# CITY OF ALBUQUERQUE

**RE: 6<sup>th</sup> and Haines Redevelopment  
Conceptual Drainage Plan  
Stamp Date: 6/20/17  
Hydrology File: H14D108**

Based upon the information provided in your submittal received 6/22/17, the Conceptual Drainage Plan **is not** approved for Site Plan for Building Permit. The following comments need to be addressed for approval of the above referenced project:

A1 EXISTING DRAINAGE PLAN  
SCALE: 1" = 20'-0"

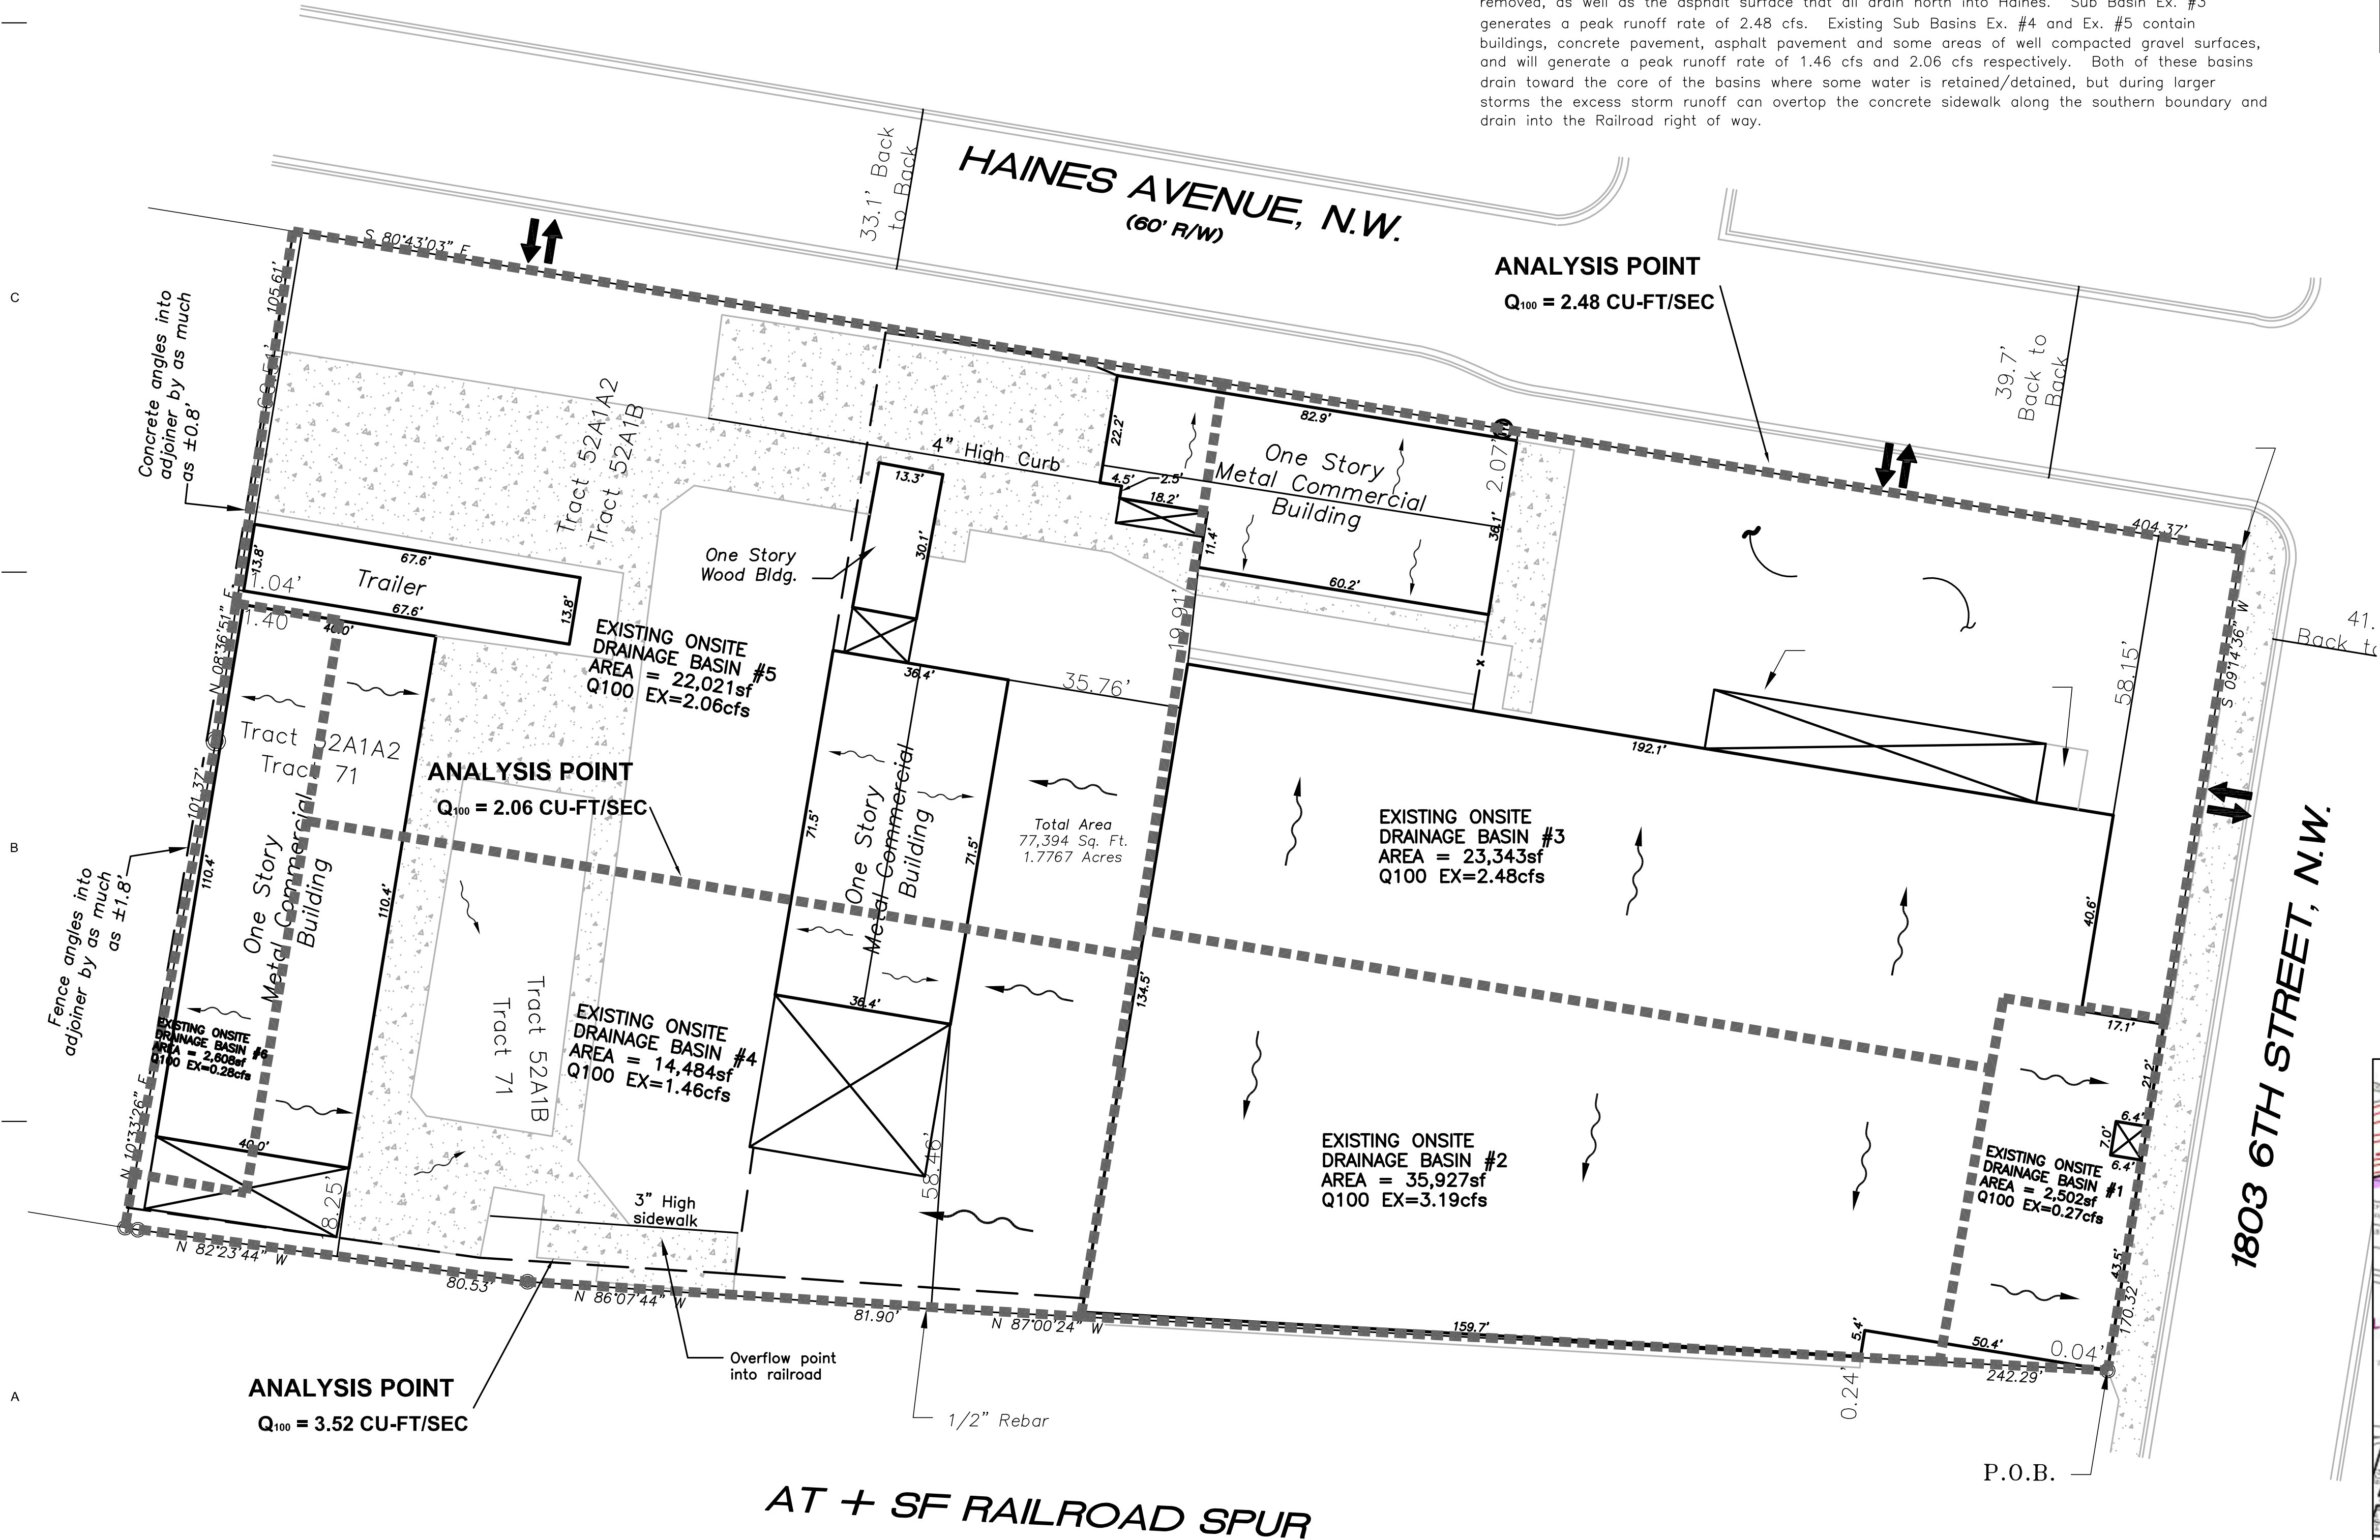
1. On Sheet CD1, please provide existing site topography. Since the site is extremely flat, please provide spot elevations. Enough to verify the drainage areas and outfalls that you have indicated. Also the existing finish floor of the buildings.
2. On Sheet CD2, please add both the existing topography along with the existing buildings finish floor. Please provide proposed spot elevations, so I can verify the proposed drainage areas and proposed outfalls that you have indicated.
3. On Sheets CD1 & CD2, please change the sheet title so that it reads, "Conceptual Grading and Drainage Plan".
